Proposed P&A NOI
State of NM Orphan Well Program
Cato San Andres Unit #67
30-025-20054

**Cato San Andres Unit 67
BLM
March 25, 2025
Conditions of Approval**

NOTICE
NEW MEXICO PLUG AND ABANDON CONDITIONS OF APPROVAL

Action 453428

State of NM Formerly Cano Petro OF NM			PROPOSED	
Author:	Abby @ JMR		Well No.	#67
Well Name	Cato San Andres Unit		API #:	30-005-20054
Field/Pool	Cato; San Andres		Location:	Sec 17, T8S, R30E
County	Chaves			660' FNL & 1980' FWL
State	NM		GL:	4106'
Spud Date	4/11/1967

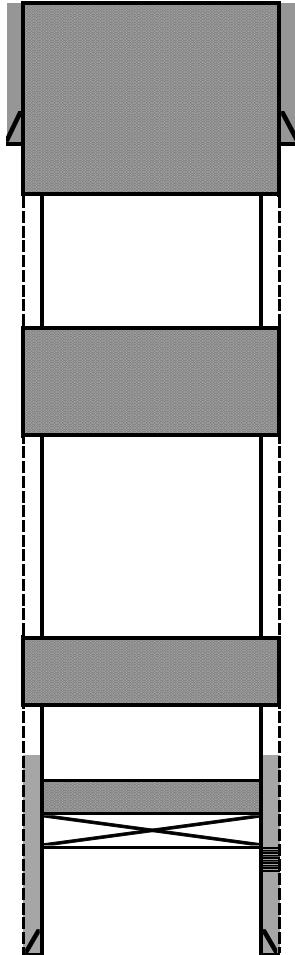
1. Operator shall place CIBP at 3,132' (50'-100' above top most perf) and place a minimum of 50 sx of Class C cement on top to isolate the top of the San Andres Formation. WOC and TAG a minimum of 2,428'.

2. Operator shall perf at 2,205' and squeeze Class C cement to 1,947' seal the Grayburg and Queen Formations. WOC and TAG.
3. Operator shall perf at 1,385' and squeeze Class C cement to 1,270' seal the Yates and bottom of the Salt Formations. WOC and TAG.

4. Operator shall perf at 1,038' and squeeze Class C cement to 772' seal the top of Salt and Rustler Formations. WOC and TAG.
5. Operator shall perf at 578' and squeeze class c cement to surface to seal the 8-5/8" casing shoe.

6. Dry hole marker must be below ground.
7. Surface reclamation will need to be completed once the well bore has been plugged. Please contact rflores@blm.gov for additional information.
